## La Jolla Shores Planned District Advisory Board (LJSPDAB) APPLICANT PROJECT INFORMATION FORM

**PRJ-1135846**
- Address and APN(s):  
**Lot 2: 0 Ruelle Nice, La Jolla, CA 92037 | 346-832-12-00**
- Project contact name, phone, e-mail:  
**Island Architects, Spencer Miller, [smiller@islandarch.com](mailto:smiller@islandarch.com), (858)-869-2830**

- Project description: **CONSTRUCTION OF A NEW 8,025 SF SINGLE FAMILY RESIDENCE, TWO-STORY DWELLING UNIT OVER BASEMENT WITH GARAGE, SPA, SITE RETAINING WALLS, AND ADDITIONAL SITE IMPROVEMENTS**

# MONTORO ESTATE

Hose Pull:

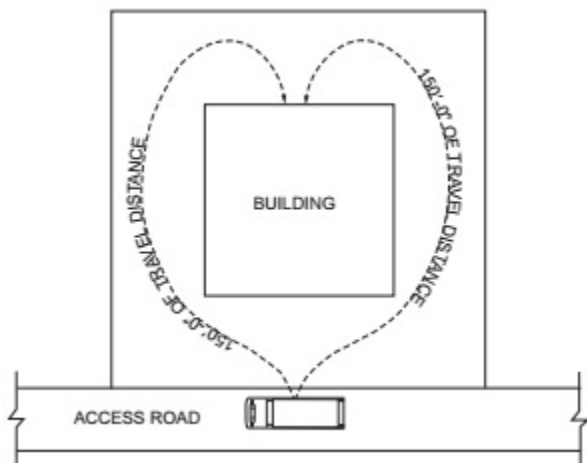
[ Comment 00013 | Sheet A1.1 | Open ]

All portions of the exterior perimeter of new buildings shall be within 150' (non-sprinklered) or 200' (sprinklered) of a fire access road. Show hose pull on plans as pictured below. Note: Fire will add 8' to hose pull calculation to account for private vehicles parked on the street.

CODE - CFC 503.1.1 Buildings and facilities. Approved fire apparatus access roads shall be provided for every facility, building or portion of a building hereafter constructed or moved into or within the jurisdiction. The fire apparatus access road shall comply with the requirements of this section and shall extend to within 150 feet (45 720 mm) of all portions of the facility and all portions of the exterior walls of the first story of the building as measured by an approved route around the exterior of the building or facility.
